SERVICE INFORMATION

YS-037-06

Subject: YMA048 & YMA060 Unit Nuisance Heat Pump Trips During Defrost

Fig 1: YMA048, HL2A048, HC2A048

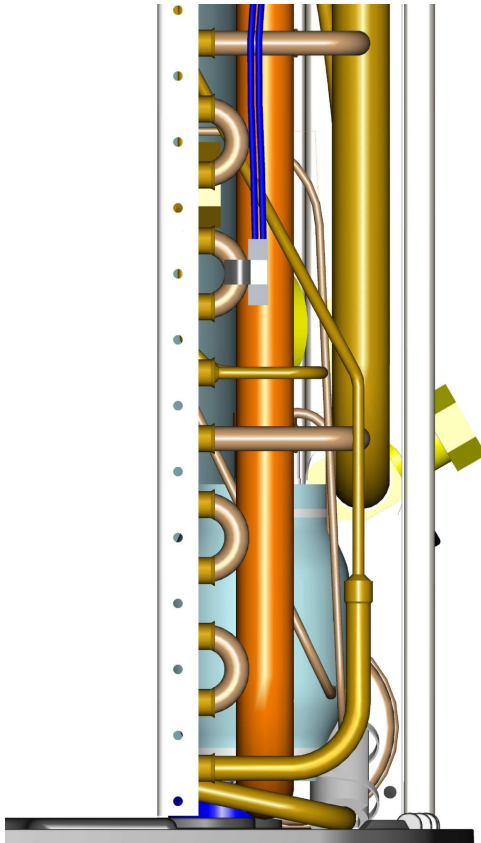
If a unit is found to trip the high pressure switch before exiting defrost the liquid line sensor can be relocated to the attached location: **Note figures one and two show where to relocate the liquid line sensor on the YMA048 units. Figures three and four shows where to relocate the sensor on the YMA060 units.**

Fig 2: YMA048, HL2A048, HC2A048

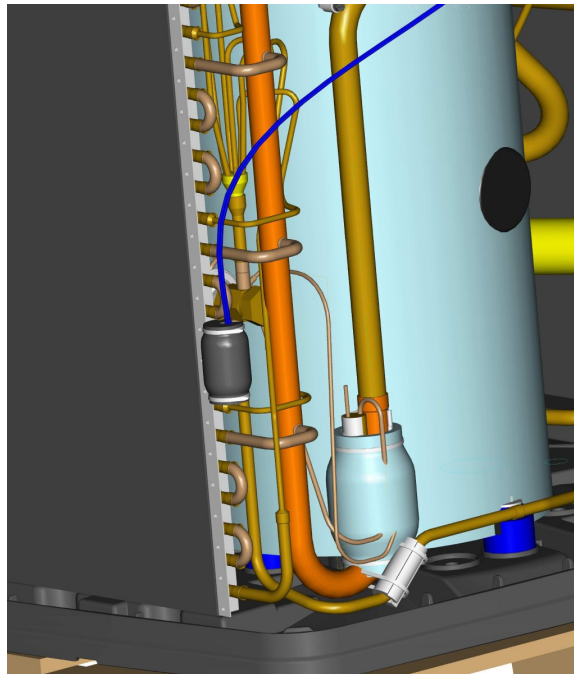
Once the sensor is relocated it must be insulated as shown in figure two.
